REMARKS

RB1-041US

Annotated Sheet Showing Changes
Amended Fig. 2
(Vnom Input Added)

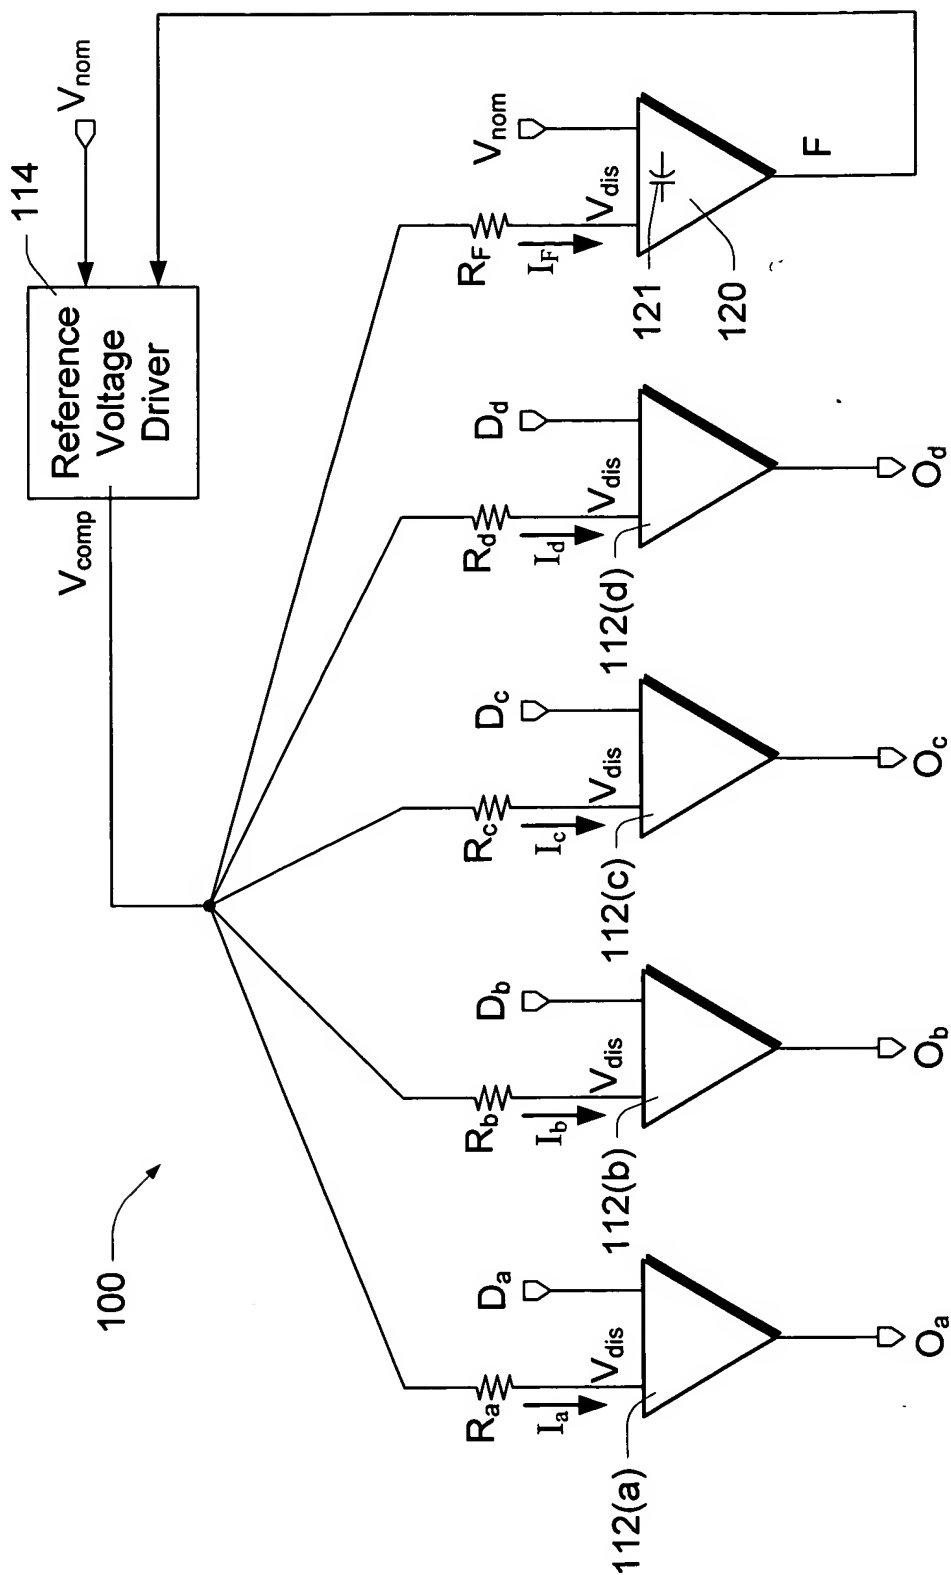
It appears that the current Office Action, at paragraph #1, is expressing that the Examiner considers the corresponding structure, material, or acts described in the specification and equivalents thereof for "routing means" to cover a resistor. However, it is respectfully submitted that the corresponding structure, material, or acts described in the specification and equivalents thereof for "routing means" covers (Patent Application, Page 6, Lines 4-8 and 19-24):

22 The current Office Action required a change to Fig. 2 with regard to element
23 114 and V_{nom} . Figure 2 has been amended so that a V_{nom} input is shown for
24 reference voltage driver 114. An “Annotated Sheet Showing Changes” is attached
25 hereto as an Appendix with the amendment (i.e., the addition) indicated in red ink.

More specifically, the distribution traces [that] have finite resistances or impedances along their lengths that contribute to the degradation or voltage change of distributed reference voltage V_{dis} . Such resistances are represented in Fig. 2 by finite resistor elements R_a through R_d , although it should be recognized that the resistances are distributed along the lengths of the traces rather than being discrete elements.

1 Also attached hereto, and included as part of this Reply, are four (4)
2 Replacement Sheets with the change to Figure 2 shown. These four (4) Replacement
3 Sheets are suitable for use as the official formal drawings.
